# Staff Report

To: Salt Lake City Historic Landmark Commission  
From: Carl Leith, Senior Planner  
801 535 7758 or [carl.leith@slcgov.com](mailto:carl.leith@slcgov.com)  
Date: December 6, 2018  
Re: **PLNHLC2018-00454 Alterations to Cottage and Additions to Adjacent Building at approximately 287 G Street and 480 6th Avenue, & PLNHLC2018-00880 Special Exceptions**

## ALTERATIONS TO COTTAGE & ADDITIONS TO ADJACENT BUILDING

**PROPERTY ADDRESS:** 287 G Street & 480 6<sup>th</sup> Avenue

1 KEYSTONE RETAINING WALL

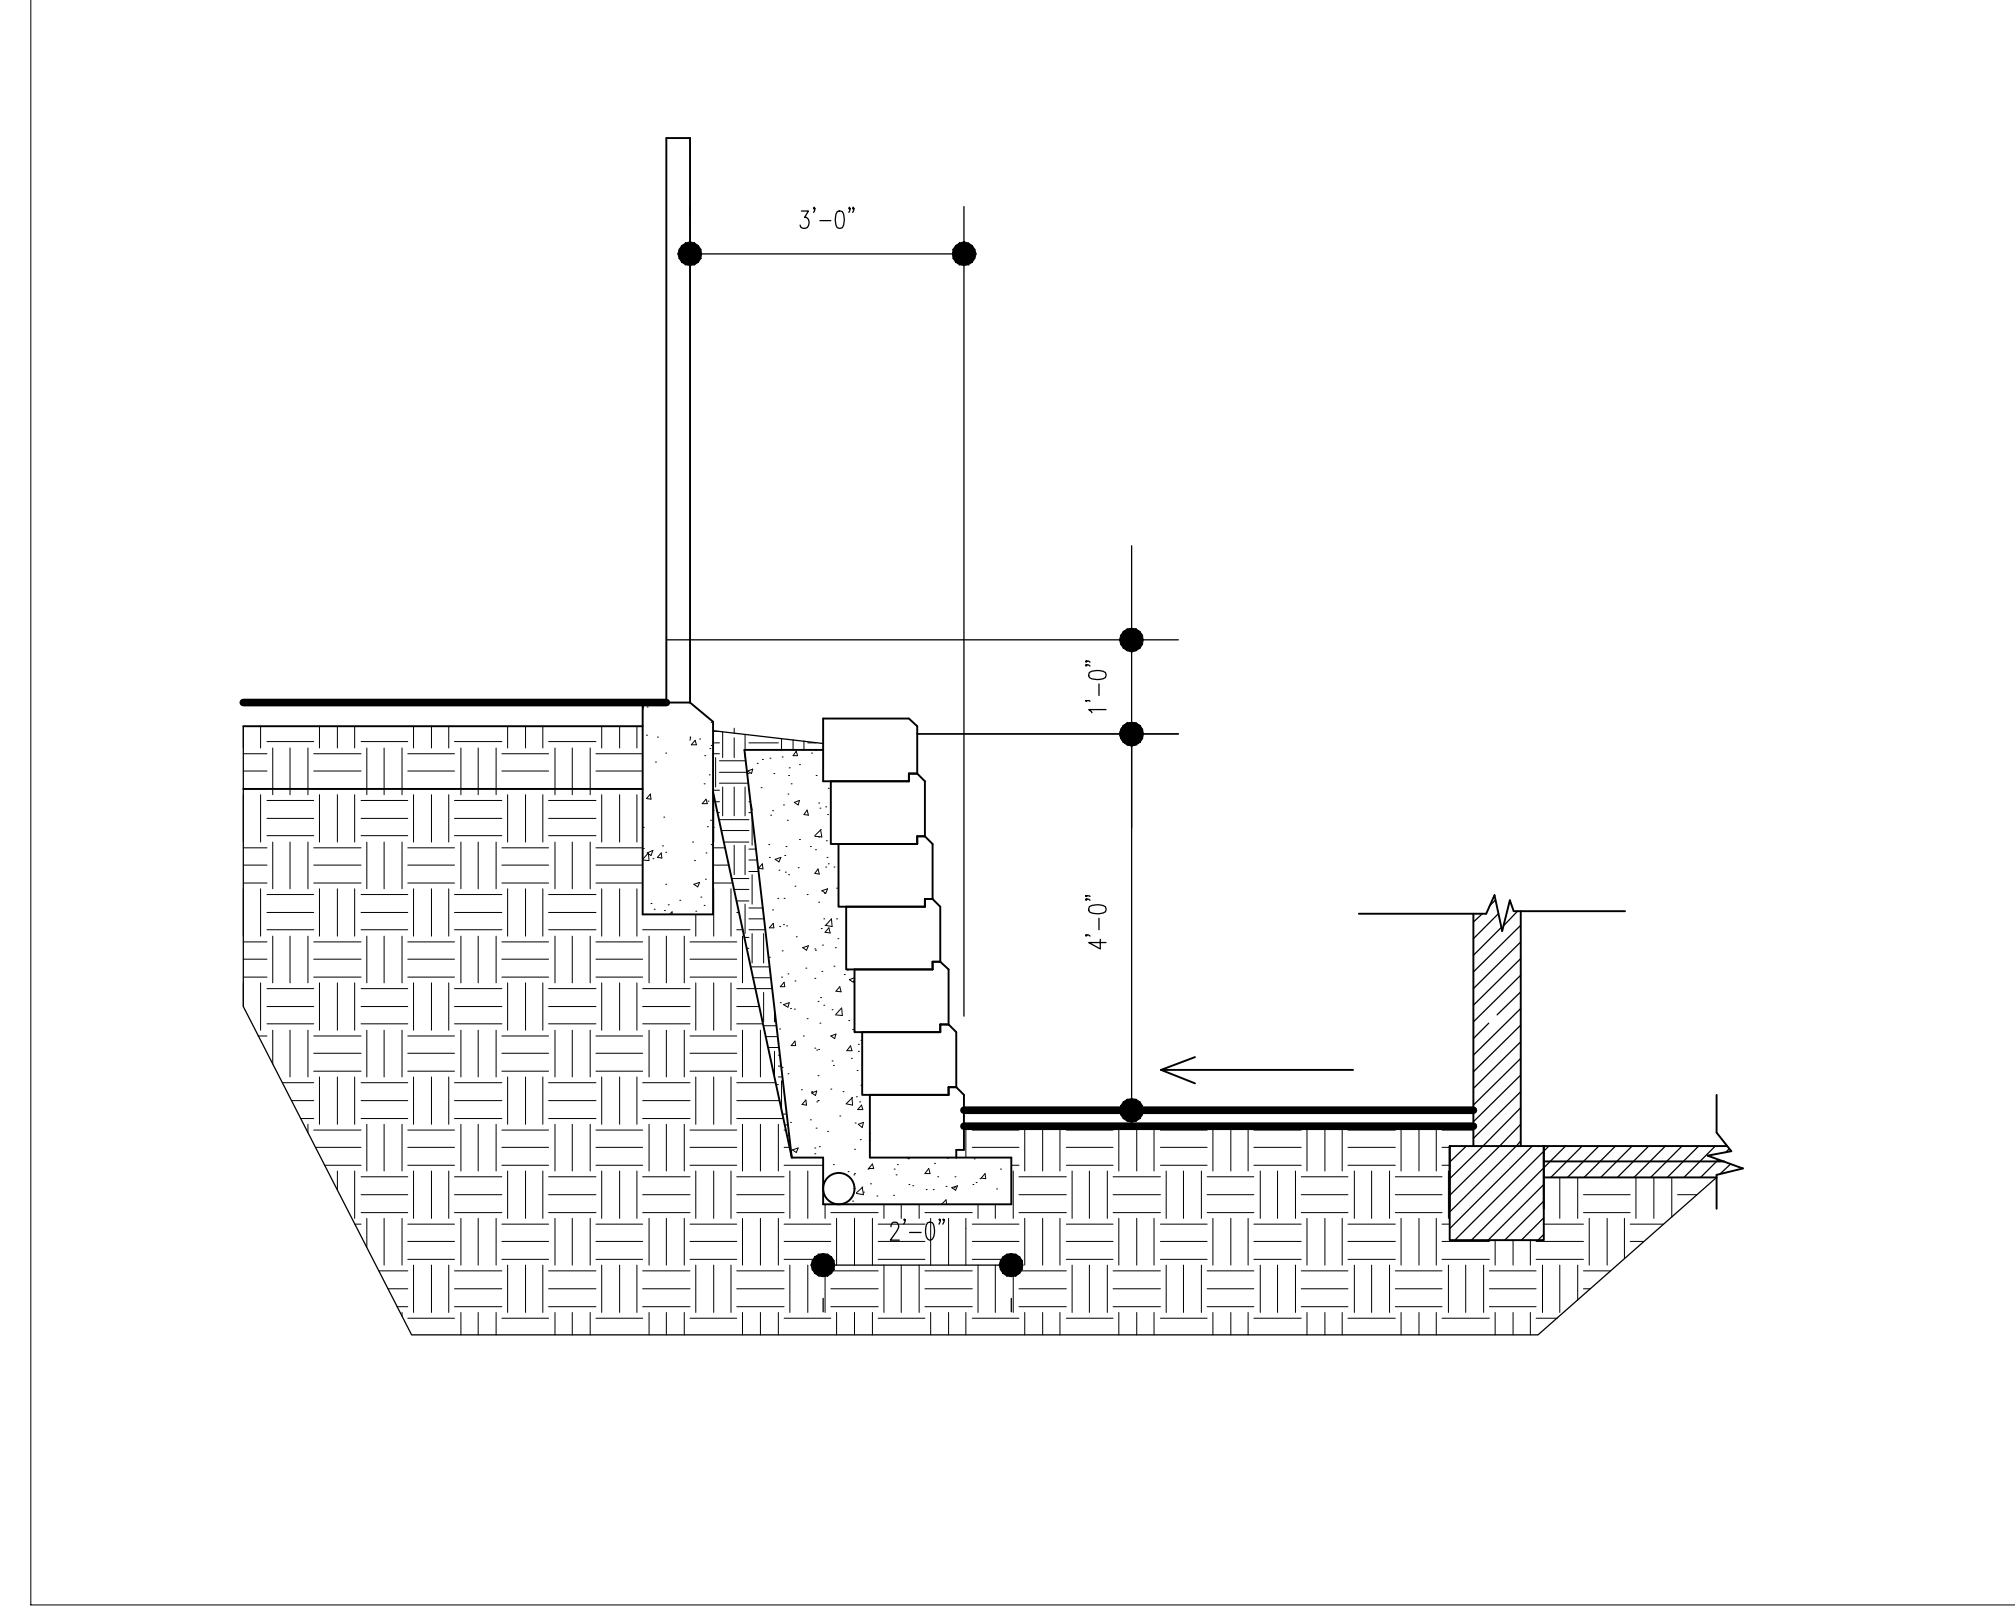
The ground level around the north side of the cottage would be reduced, sloped away from the building and supported by a new retaining wall. The north, east and south facades of the cottage would be retained, re-supported and repaired. The roof would be removed during construction, stored, and reinstated. Existing windows would be retained and repaired. The blocked in window on the south façade would be reinstated to match existing historic windows. Refer to Attachment E for Application Materials.

**2 PROPOSED SITE PLAN**  
 1/4"=1'-0" IF THIS SHEET IS NOT 36X24 THEN IT IS A REDUCED SIZE PLOT.  
 USE GRAPHIC SCALE ACCORDINGLY.

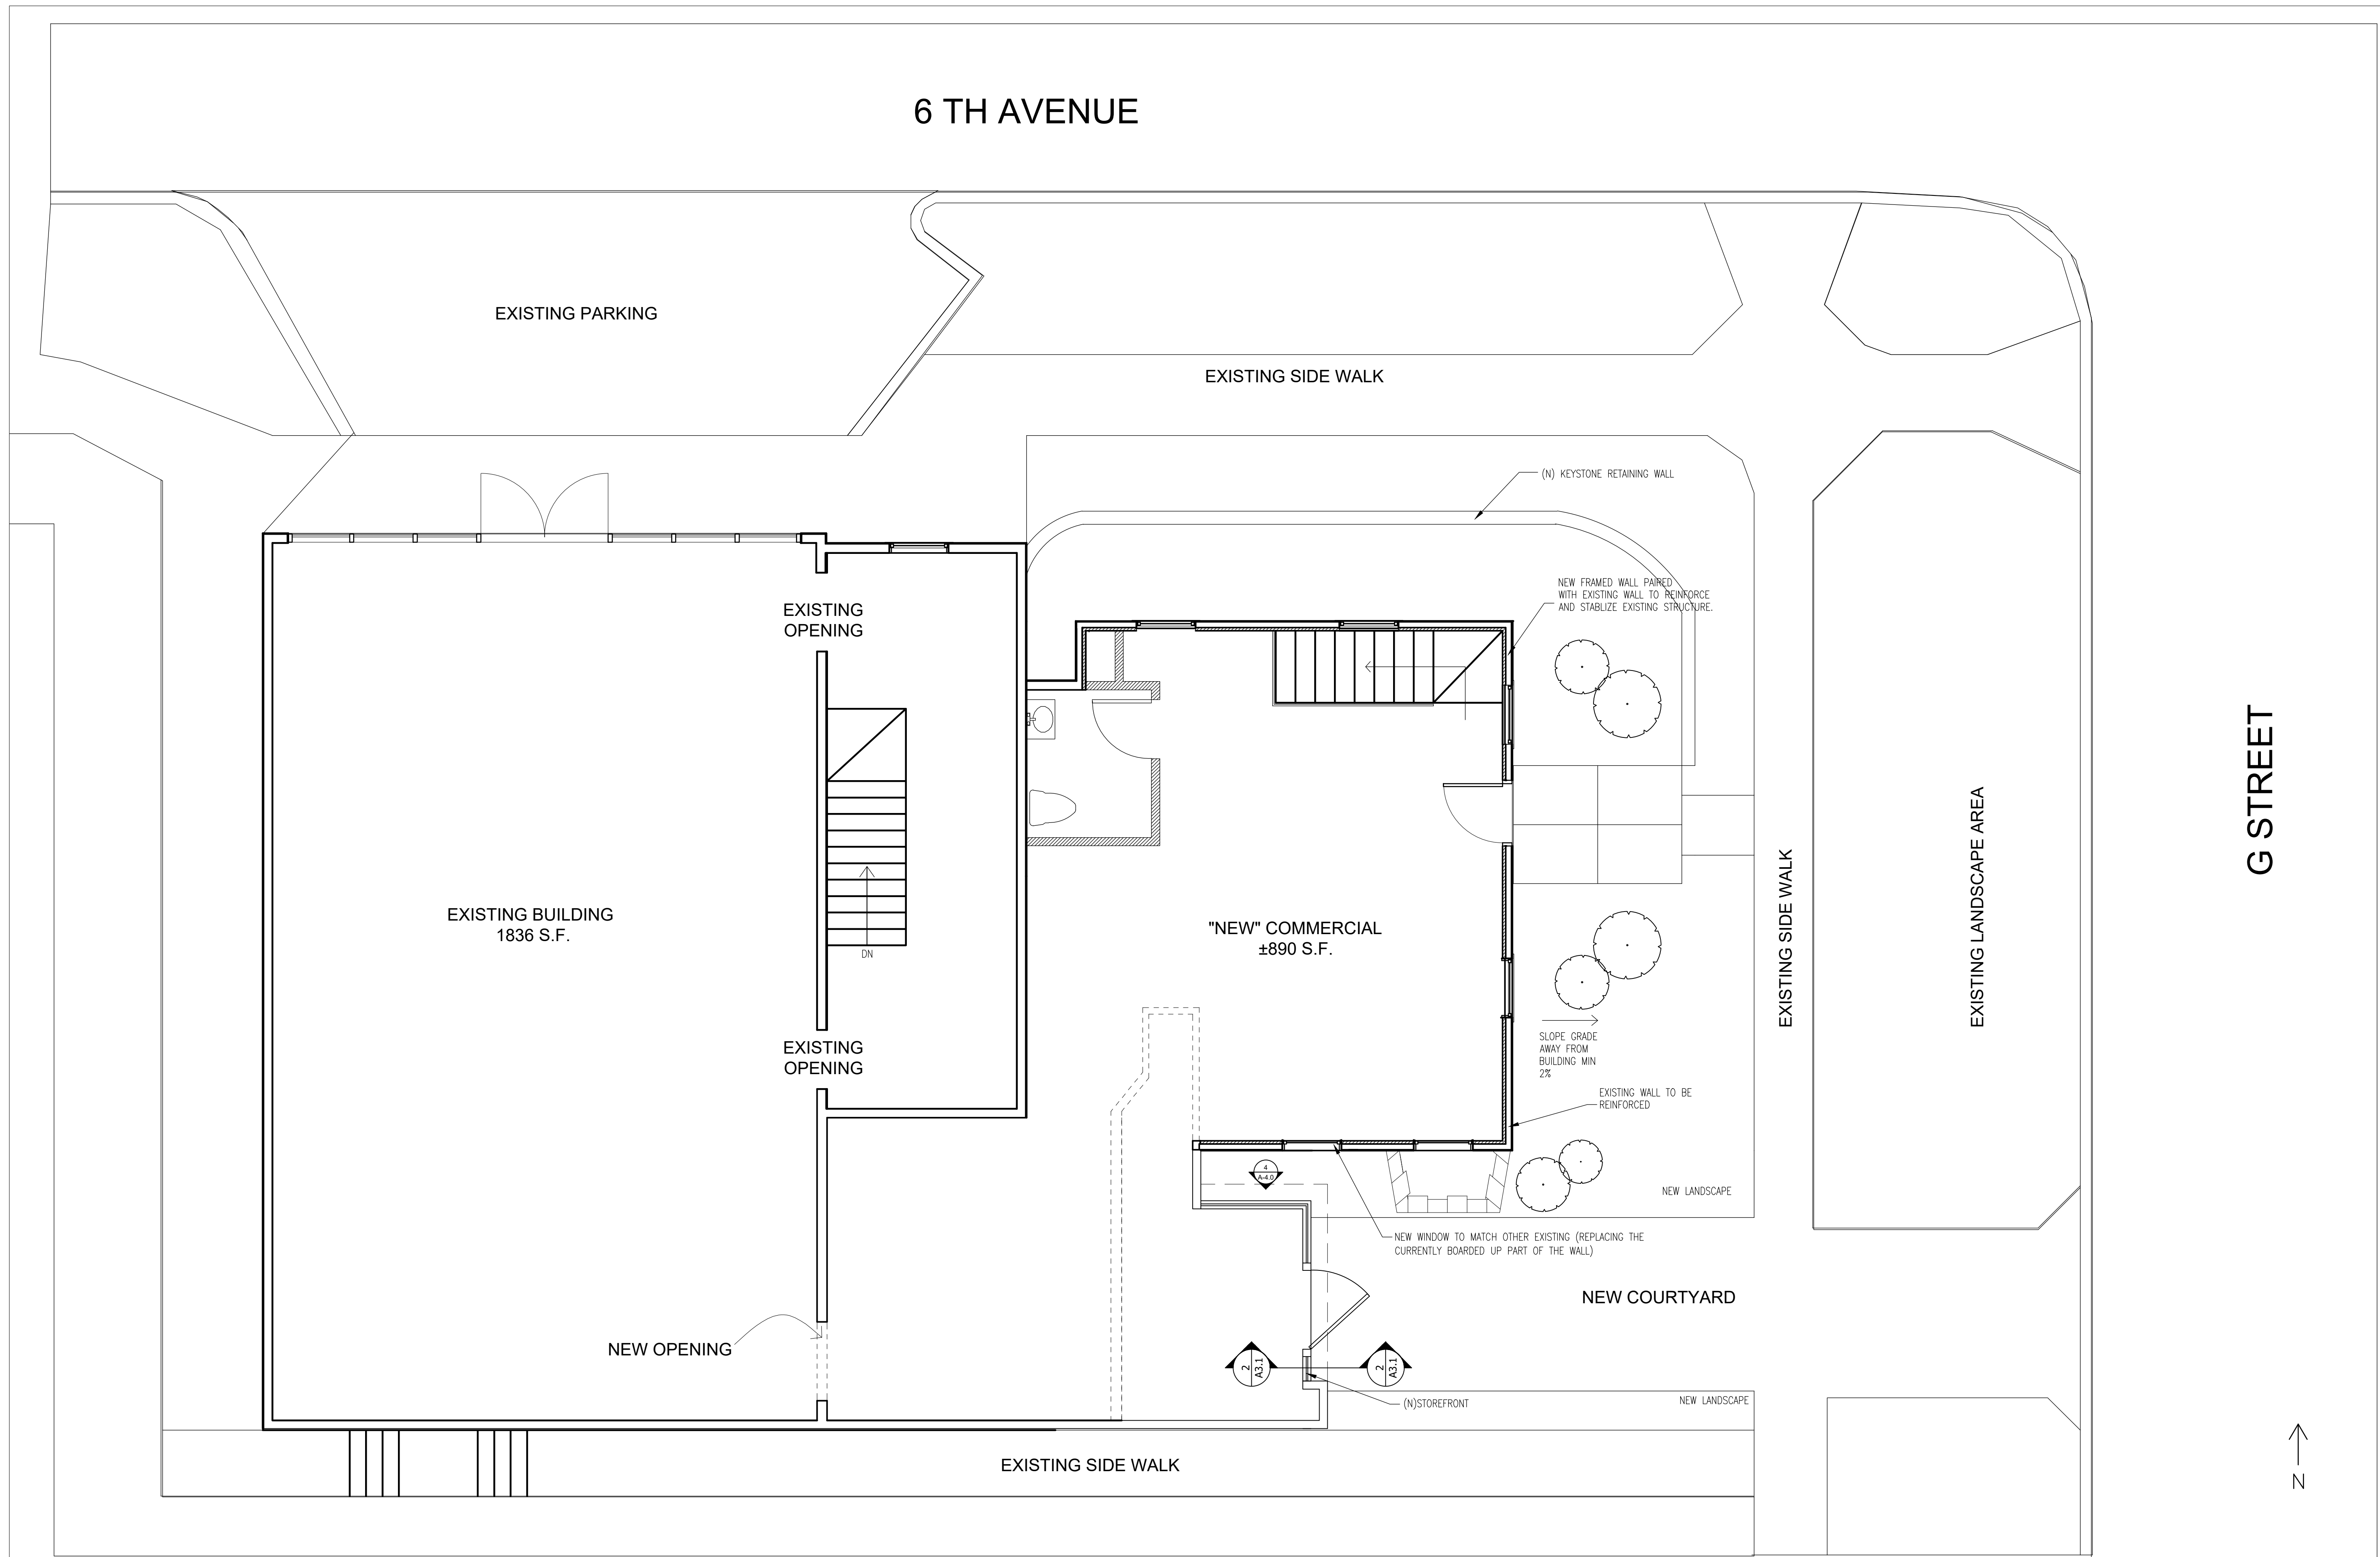
- Construction up to 1 ft 1 in within the side yard setback area, continuing the existing line of south façade of the 480 6<sup>th</sup> Avenue commercial building, and
- Increasing the building coverage on this lot from its existing 56.5% to 60%.

NOTES:  
 EXISTING BUILDING COVERAGE : 56.5%  
 PROPOSED BUILDING COVERAGE : 60%

Both buildings occupy the same lot and both buildings in various respects do not conform to current SR-1A standards. The south addition proposed in this case continue the existing wall plane within the inner side yard setback in the form of an in-line addition. Combined, the additions increase the building coverage on this site by 3.5%, with little appreciable impact upon current form and configuration. Staff would conclude that the special exceptions sought for this development would meet the objectives of the historic district purpose and standards, would not conflict with the purposes of the SR-1A zoning district or the objectives of the special exception standard and generally would be compatible with the historic character of existing development in this context within The Avenues Historic District.
